Applicant requests a Special Exception from Section 2.16.050 K (Carport over a Driveway) in an R-3 zone.

This would permit the construction of a 14' by 22' carport that is proposed to be located to within 2 feet of the front property line.

I have reviewed the plans for ZBA Case #ZBA08-00071, located at 10556 Clearwater St. The applicant is requesting a Special K Exception under Title 2.16.050 for a carport over the driveway.

SUBJECT: **ZBA08-00071 Clearwater and Wadsworth, Revised**
Carport over driveway

Plot Plan
Scale 1"=20'

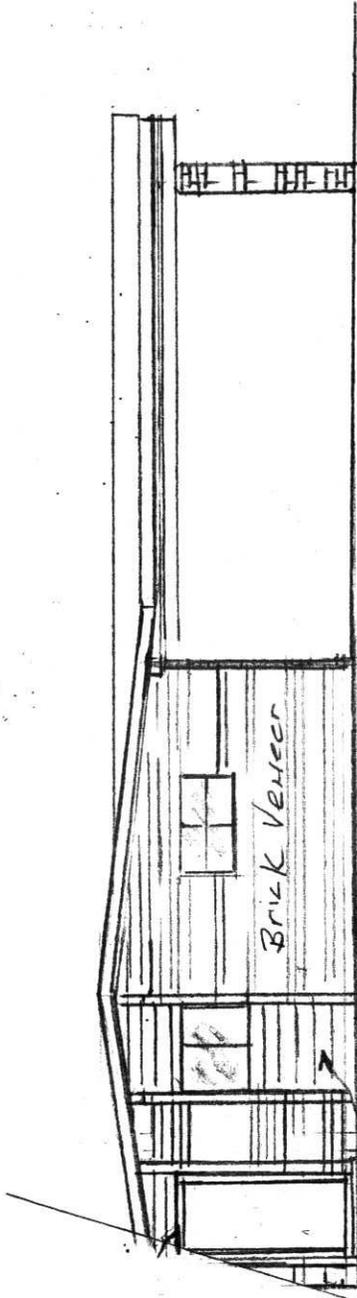
The applicants are requesting to construct a carport over a driveway. The driveway is located within the 20' visibility triangle at the intersection of Clearwater and Wadsworth streets. The Engineering-Traffic Division has reviewed the site and notes that they will approve the driveway if the supporting columns are not "too big." The columns are approximately 15" square. There are no utility easements located at the front of the property. The Building Permits & Inspections Division has reviewed the structural plans and notes that the plans are acceptable.

Required front yard setback = 25'

Requested front yard setback = 2'

Staff recommends **Approval** of the Special Exception K as the request meets the requirements of the Special Exception as submitted.

Floor Plan
Scale 1/4" = 1'0"

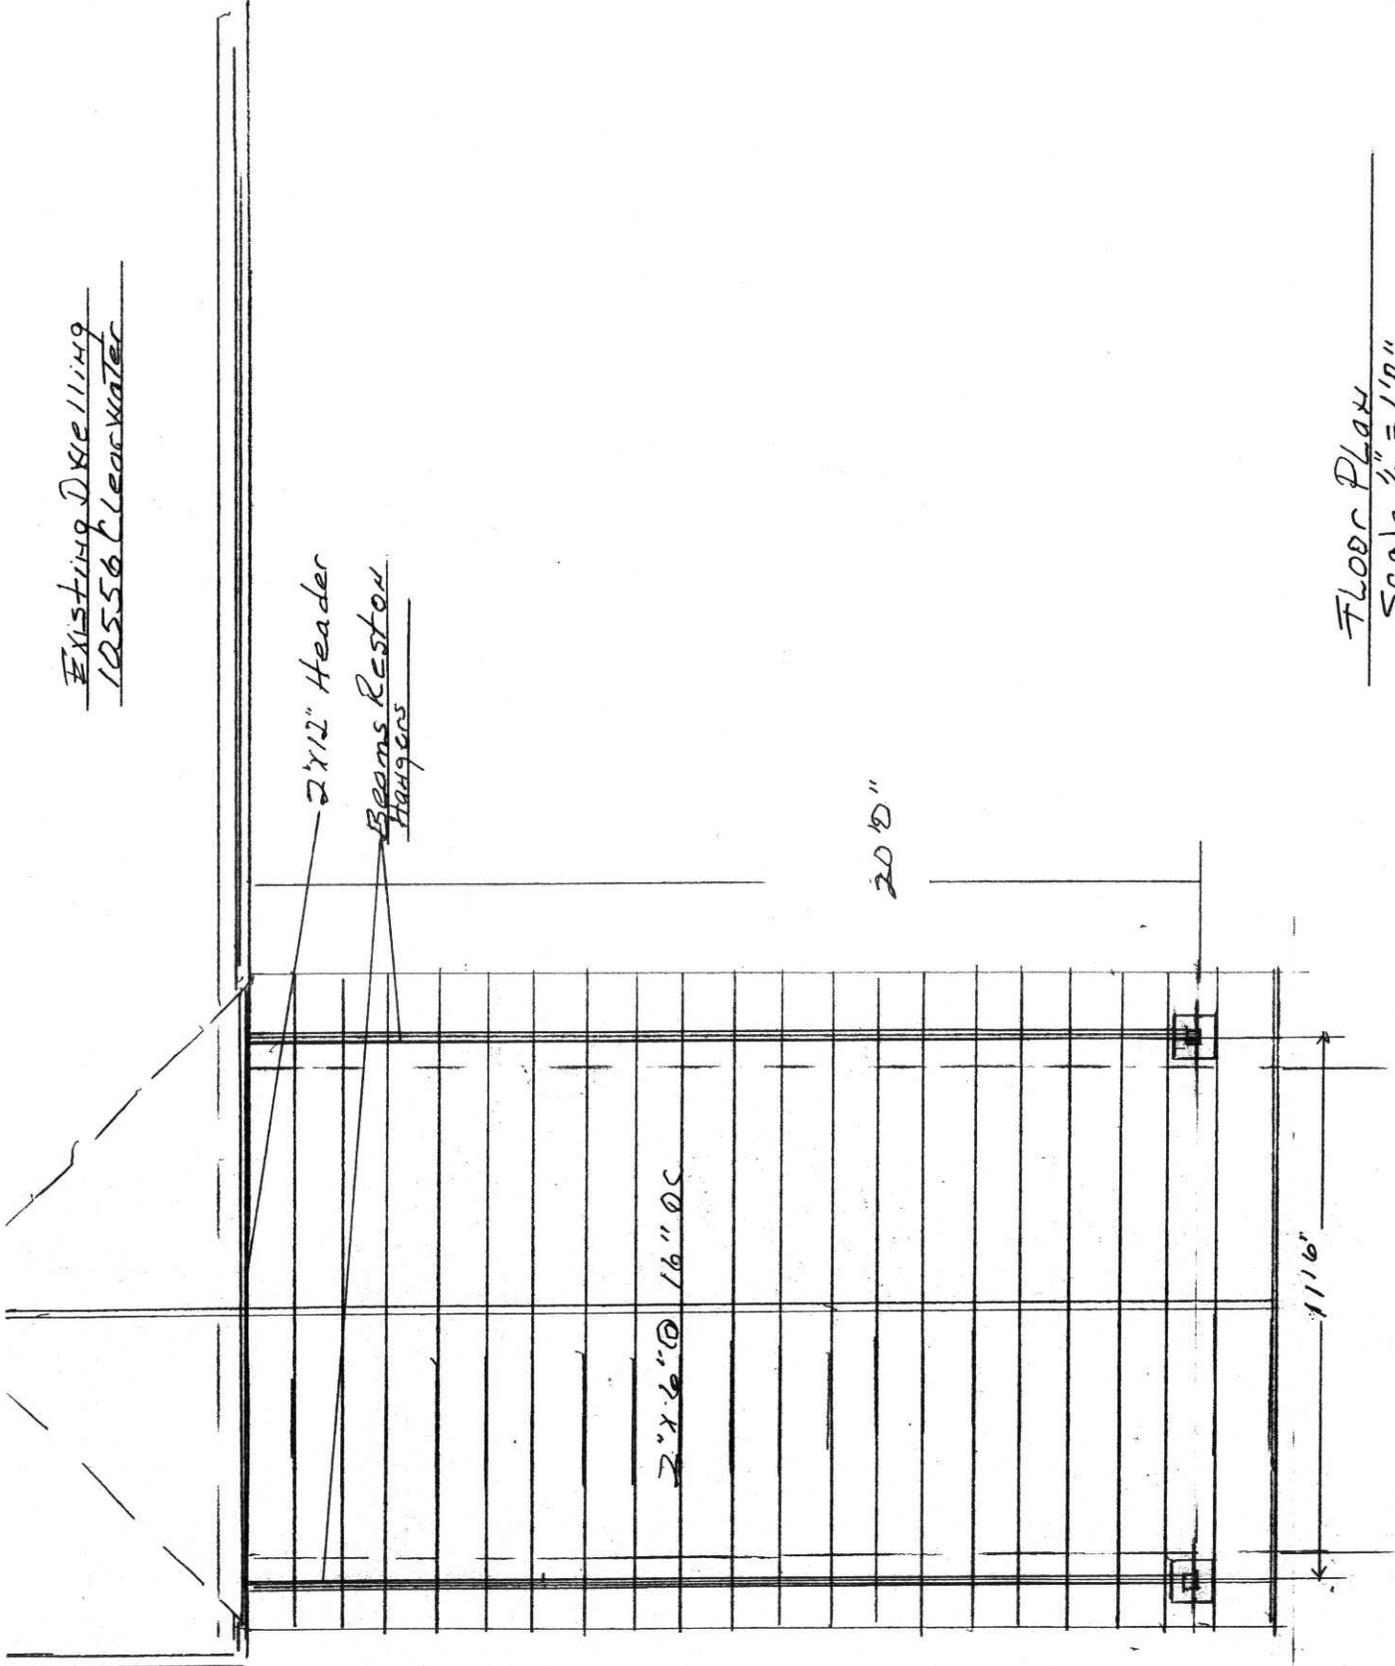
The carport's structural design has been reviewed and has been found to be acceptable.

This letter is written pursuant to Title 2.16.050.5 and provides written approval for the carport design based upon structural design considerations from the Building Permits and Inspections Section of Development Services.
